CITY OF ALBUQUERQUE

Re: Solare Collegiate Charter School
8801 Gibson Blvd. SW 87121
Traffic Circulation Layout
Engineer's/Architect's Stamp 06-07-2019 (M09D031)

Based upon the information provided in your submittal received 07-18-2019, the above referenced plan cannot be approved for Building Permit until the following comments are addressed:

TITLE
Traffic Control Layout

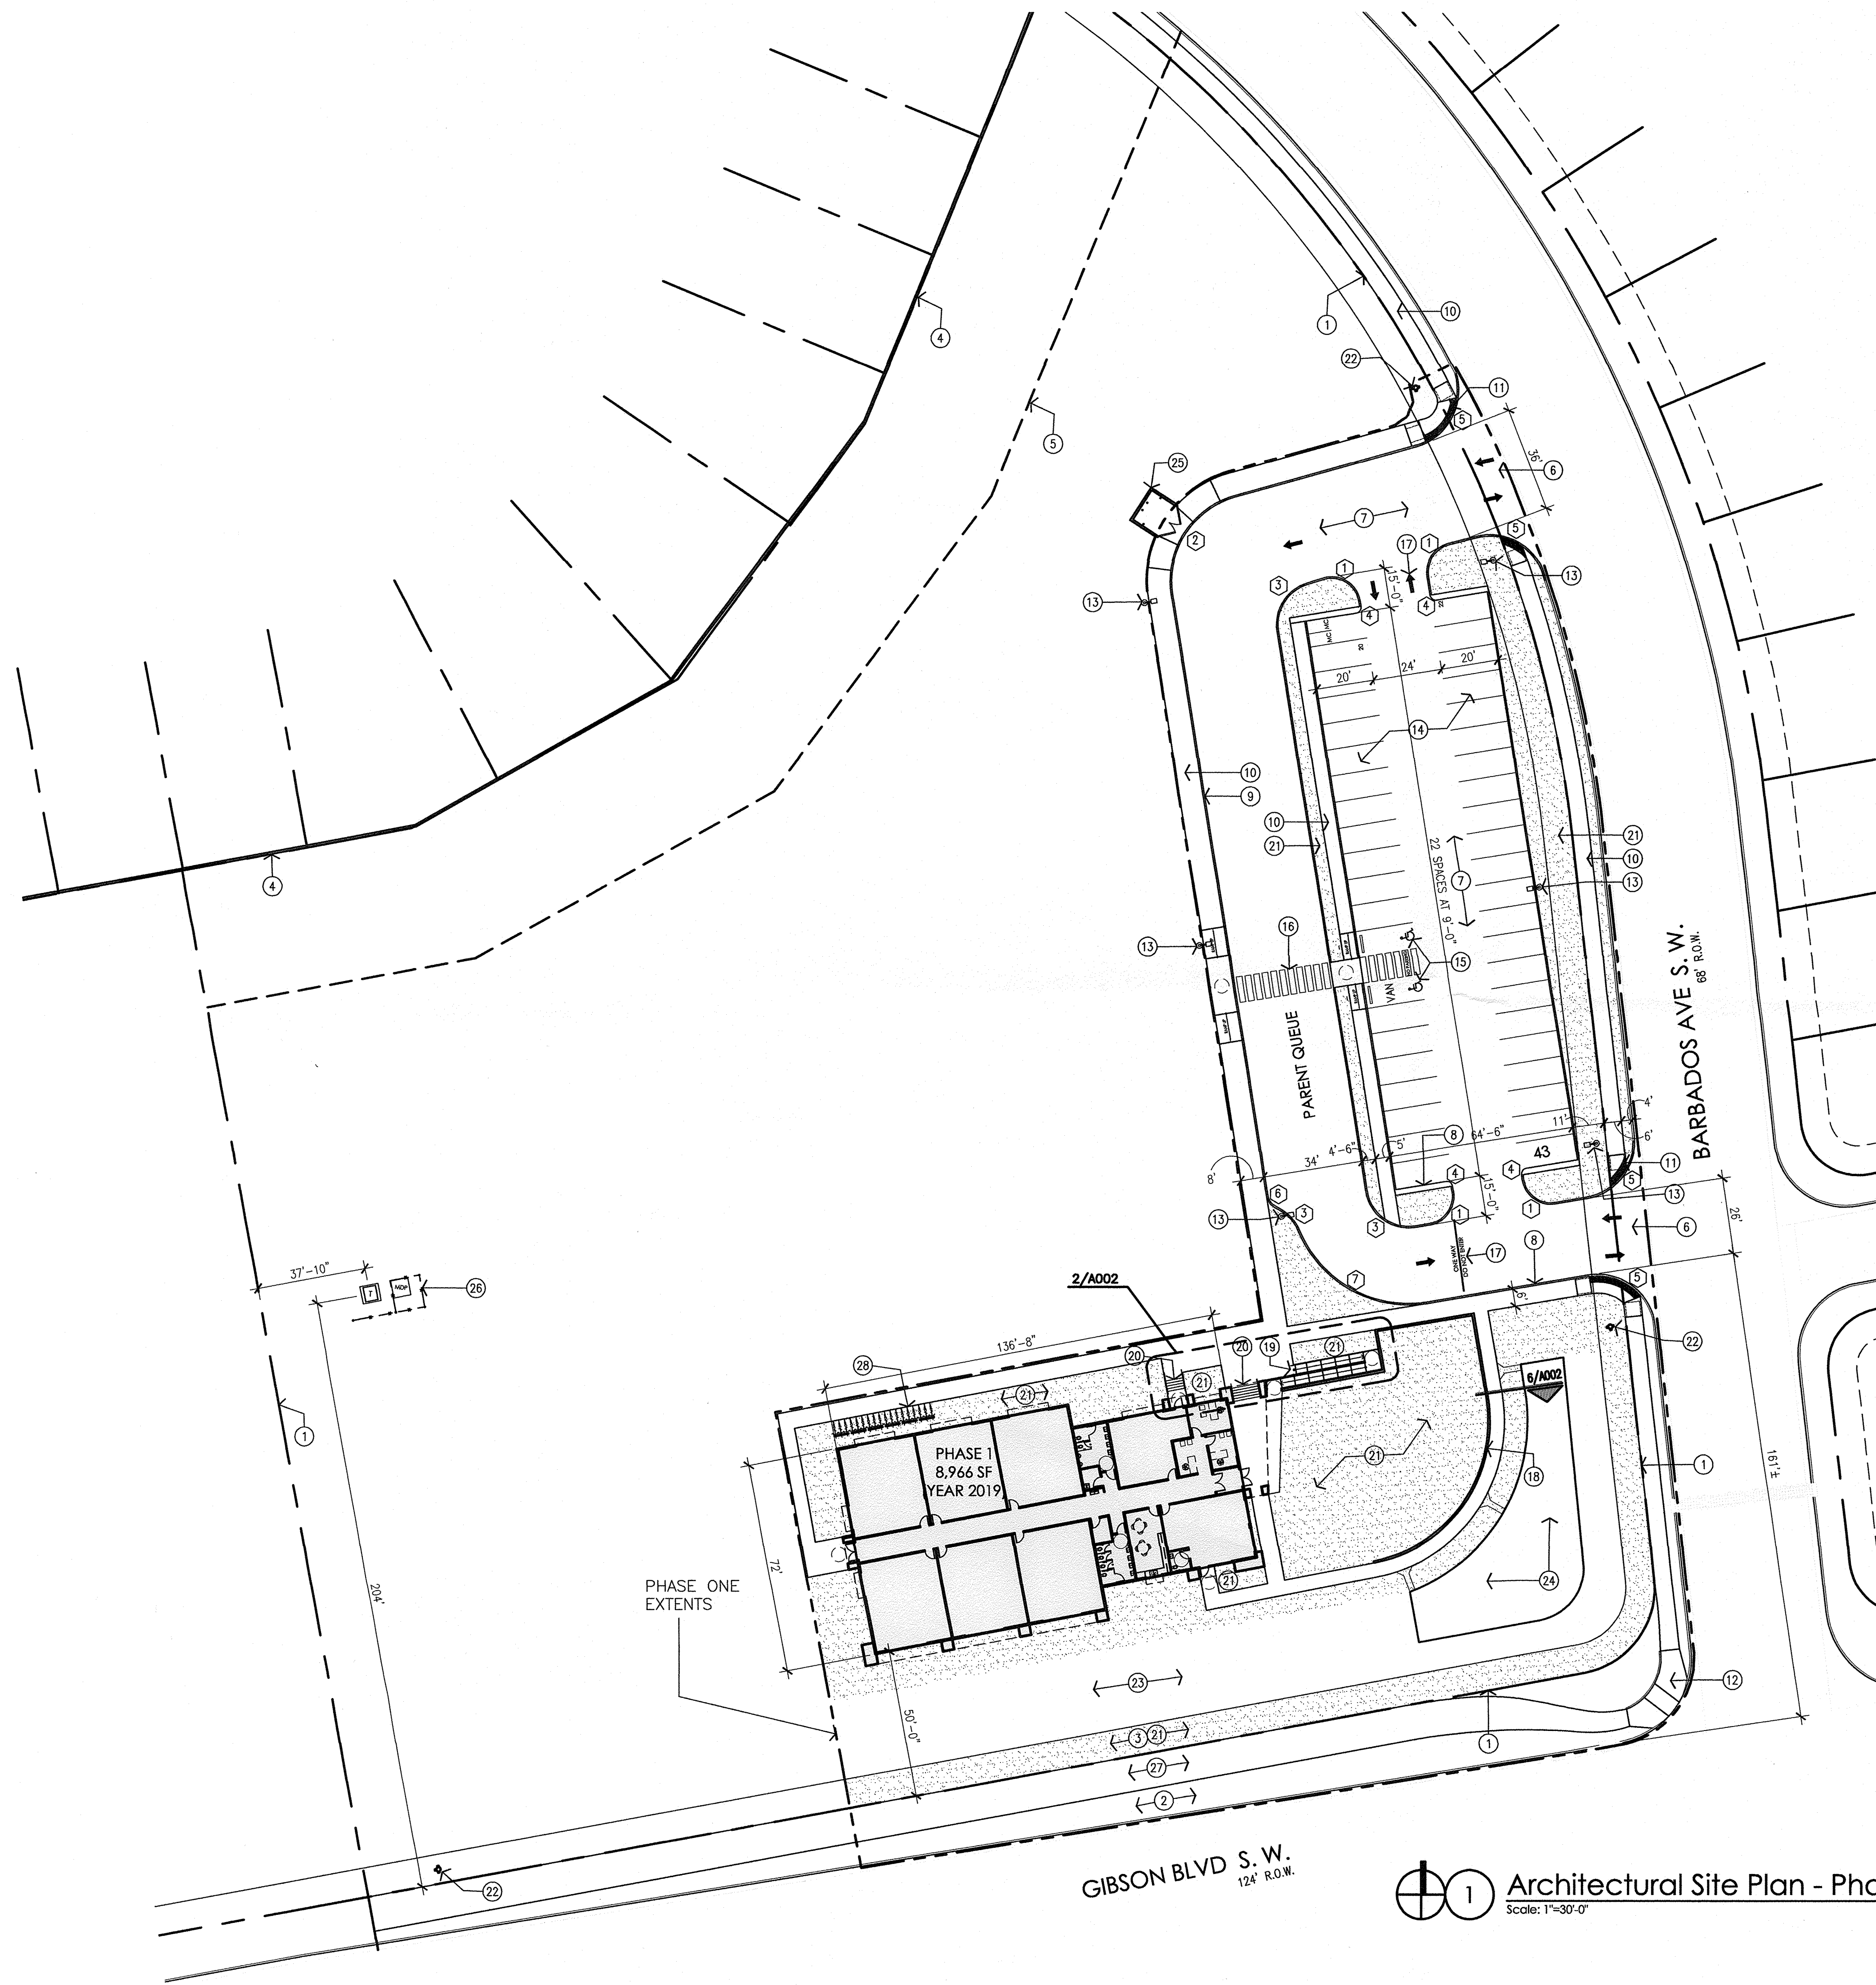
1. One-way vehicular paths require pavement directional signage and a posted "**Do Not Enter**" sign at the point of egress. Please show detail and location of posted signs.

2. Show the clear sight triangle and add the following note to the plan: "Landscaping and signage will not interfere with clear sight requirements. Therefore, signs, walls, trees, and shrubbery between 3 and 8 feet tall (as measured from the gutter pan) will not be acceptable in the clear sight triangle."

3. Please line up your access on Barbados Ave. SW with ranchers Rd. SW.
4. Provide notes showing what work is included and on the work order and the private work on site.

5. Work within the public right of way requires a work order with DRC approved plans.
6. Please add a note on the plan stating, "All improvements located in the Right of Way must be included on the work order."

7. Please match the infrastructure list with what is shown on TCL. The sidewalk on Barbados Ave SW is not shown in the infrastructure list.
